FLYING HORSE NORTH FILING NO. 4
CONSTRUCTION DOCUMENTS
A TRACT OF LAND BEING A PORTION OF SECTION 30, TOWNSHIP 11 SOUTH,
RANGE 65 WEST OF THE 6TH P.M., AND A PORTION OF SECTION 31, TOWNSHIP 11
SOUTH, RANGE 65 WEST OF THE 6TH P.M.,
CITY OF COLORADO SPRINGS, COUNTY OF EL PASO, STATE OF COLORADO

AS-BUILT VERSION 1.0, DATED 7/22/2026
PE: RICHARD LYON
CO PE NO. 53921

FLYING HORSE NORTH FILING 4
PRI #2, LLC.
EL PASO COUNTY, CO

STORM SEWER PLAN & PROFILES
STORM CULVERTS

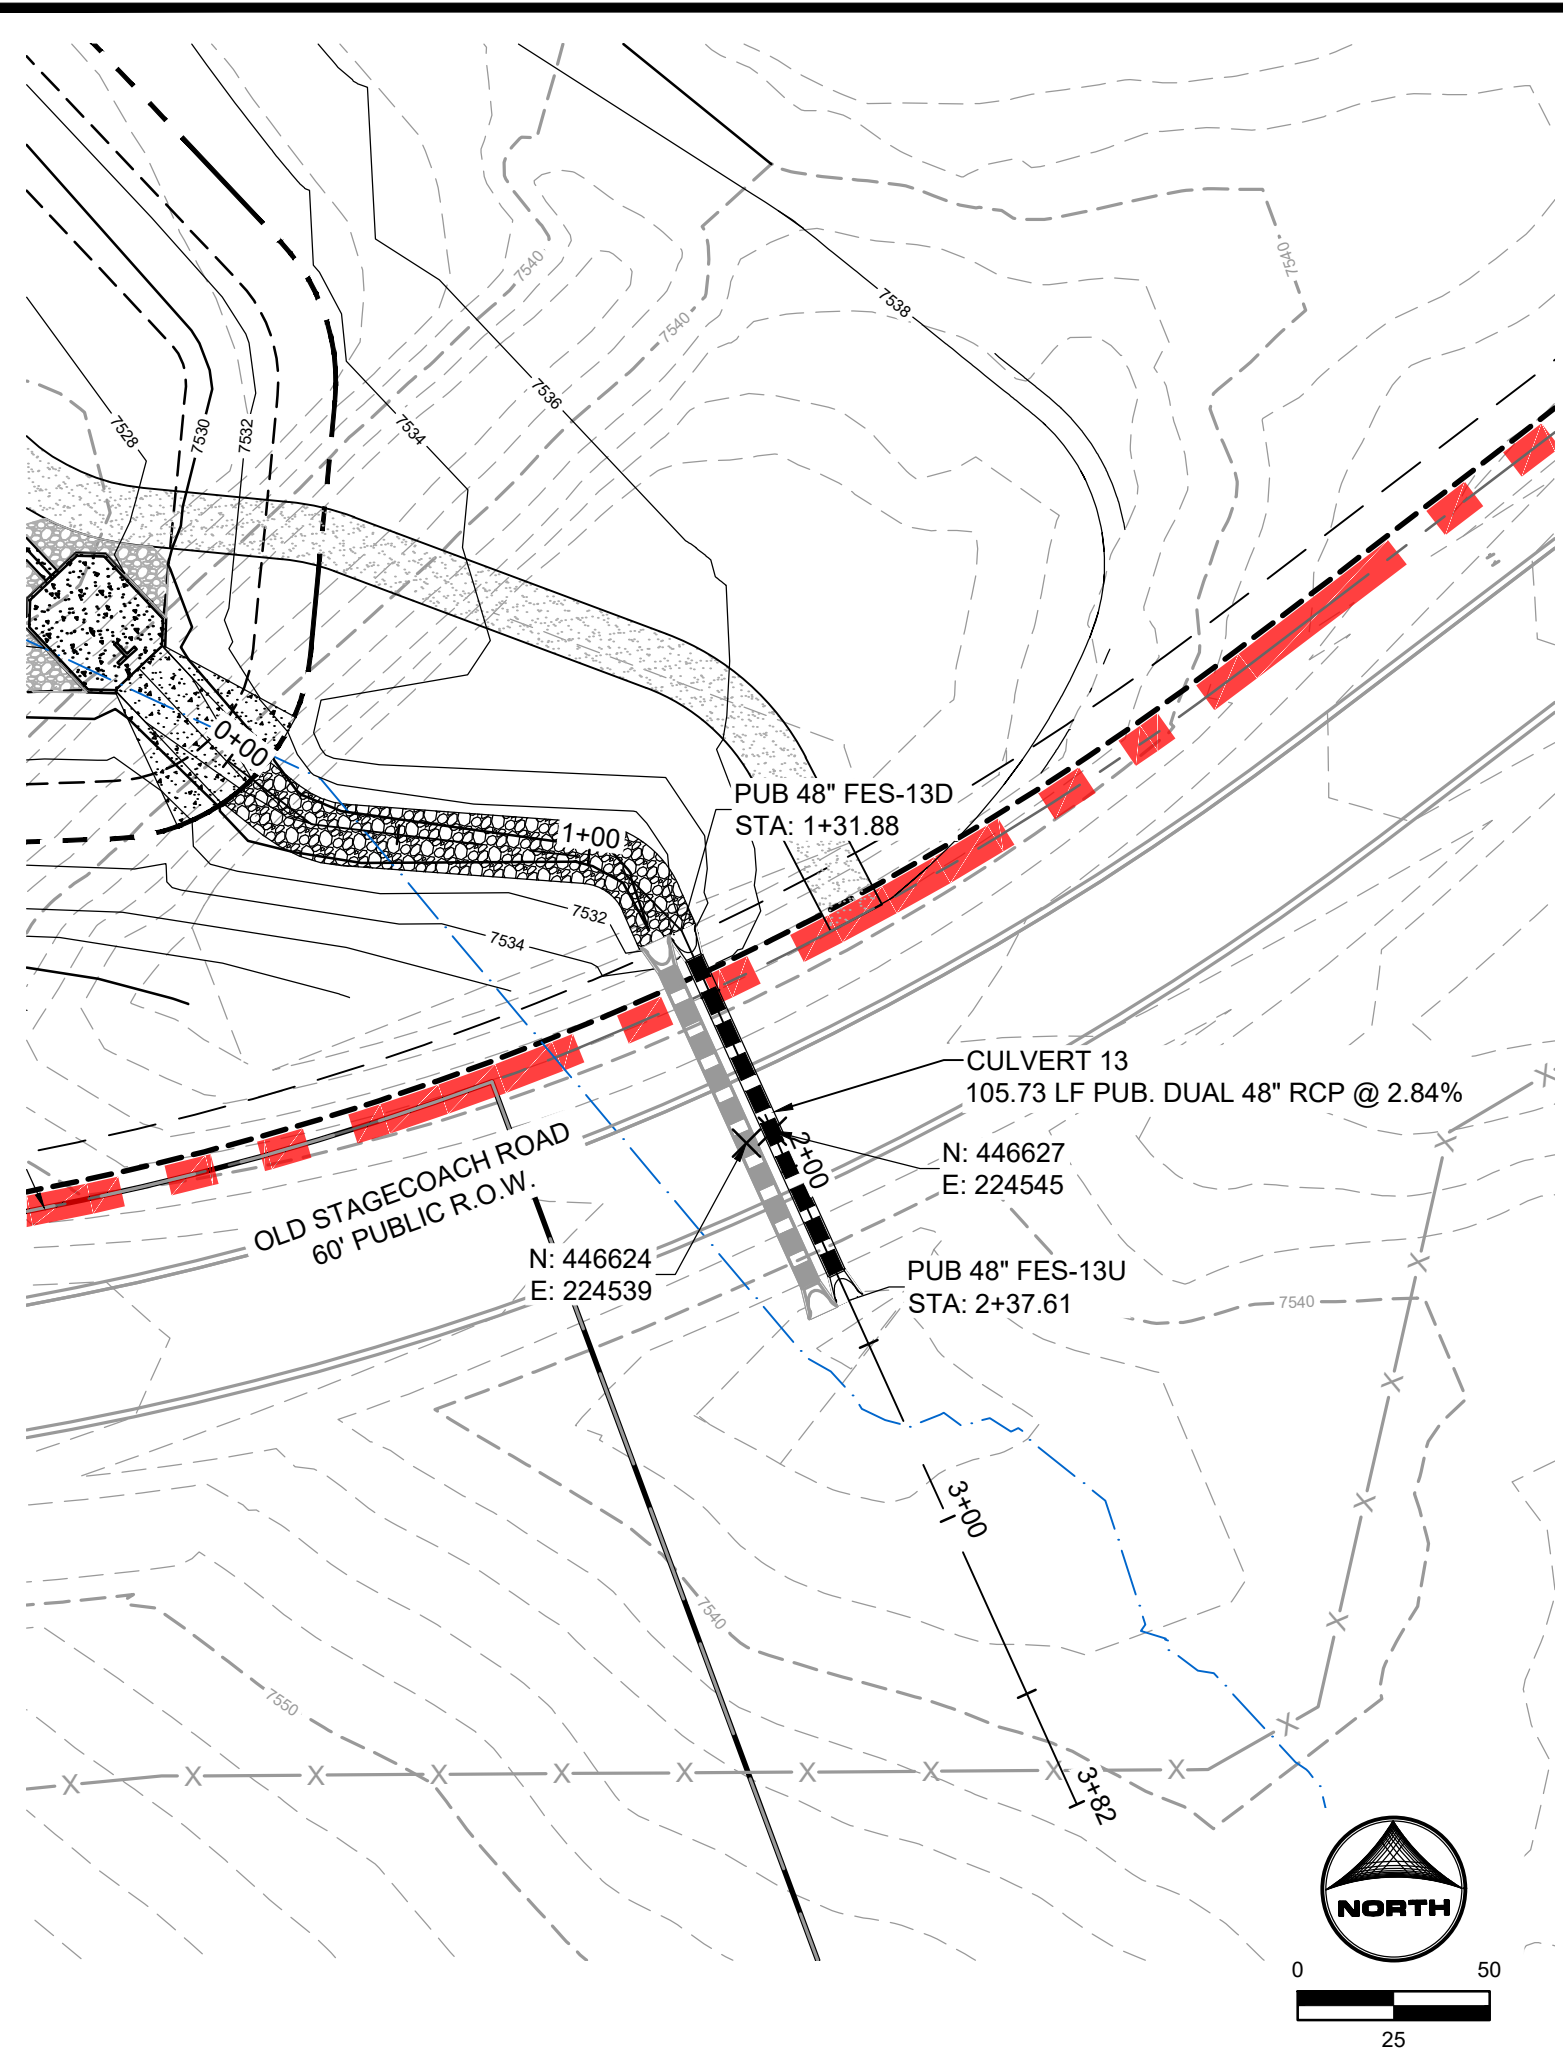
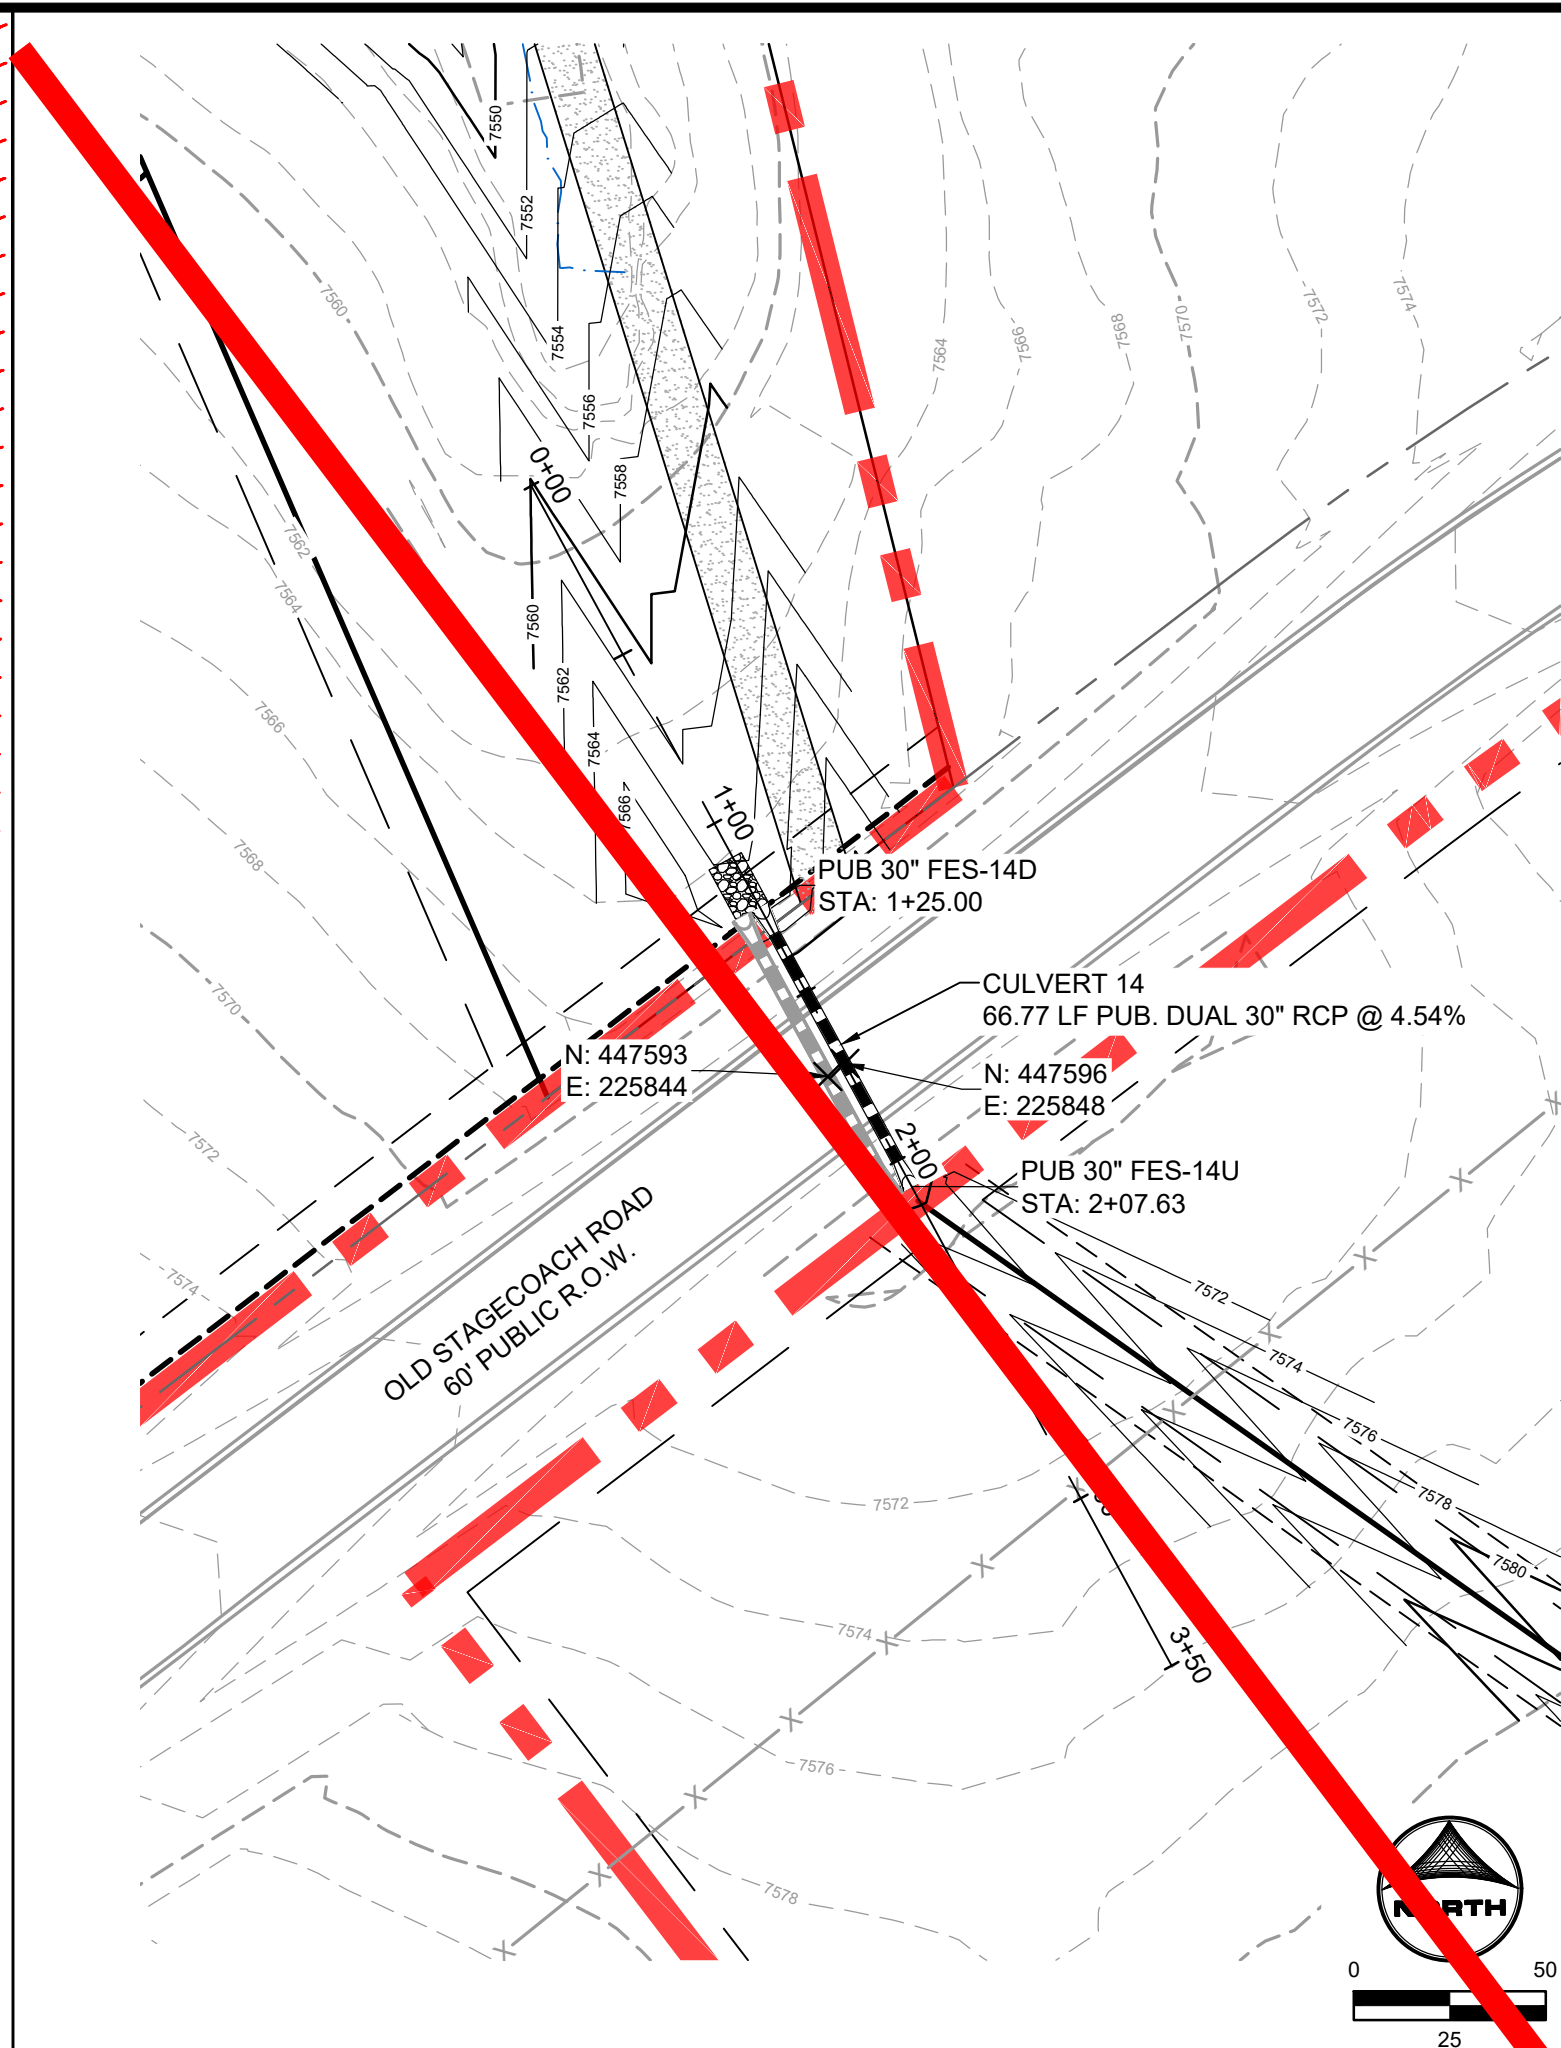
SHEET 18:
- APRIL 2025: DISCUSSIONS WITH EPC
PUBLIC WORKS STAFF, DETERMINATION
THAT CULVERTS 14 AND 15 WERE NOT
REQUIRED TO BE INSTALLED.
